Access Compliance Report

Public Rights-of-Way

(Curb Ramps)

Intersection ID: 6300	Main Street: JORDANS_POND_LN	Cross Street: VALLEYDALE_RD	Location: W
ADA ID: EFCC8E242DDD	Ramp Type: PerpDiag	Initial Pass/Fail: Fail	Overall Compliance: No
			Severity Score: 13.75

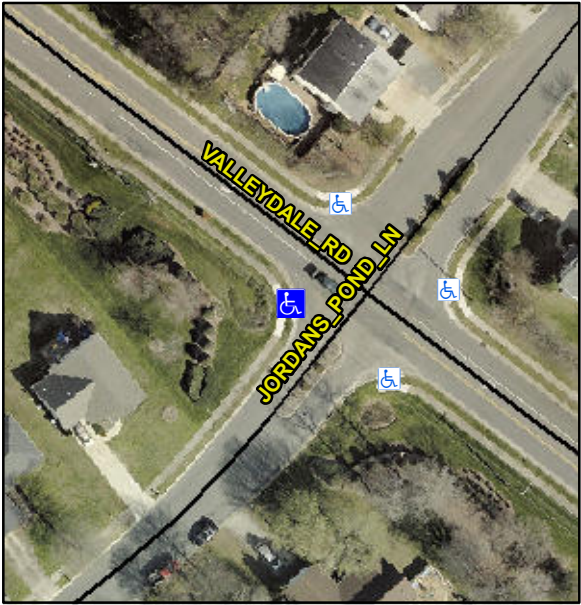
Codes/Mitigation Info/Possible Solution			Field Measurements/Component Compliance		
 Street 1 Name: JORDANS POND LN Stop Condition-Street 2: StopSign Street 2 Name: VALLEYDALE RD Stop Condition-Street 1: None	Possible Solutions:		Compliance	Description	Data
	Remove & Replace Curb Ramp With Two New Directional Ramps or Equivalent.		N/A	Ramp Length (in)	51.5
			Yes	Ramp Width (in)	48.0
			N/A	Flare Type LT	N/A
			N/A	Flare Slope LT (%)	N/A
			N/A	Flare Traversable LT?	N/A
			N/A	Landing Length (in)	N/A
			N/A	Landing Width (in)	N/A
			N/A	Landing Slope (%)	N/A
			N/A	Landing X Slope (%)	N/A
			N/A	Landing Curb? (Y/N)	N/A
			N/A	Shared Landing?	N/A
			N/A	Gutter Ponding?	N/A
			N/A	Gutter Lip Ht (in)	N/A
			N/A	Painted X Walk1?	No
				X Walk 1 Direction	To SE
			N/A	X Walk 1 Width (in)	N/A
				X Walk 1 Slope (%)	3.5
				X Walk 1 X Slope (%)	2.3
			N/A	Ramp inside XWalk1?	N/A
Surveyor Notes: N/A PROW/ADA: R304.2.2, R304.5.3			N/A	Flare Type RT	N/A
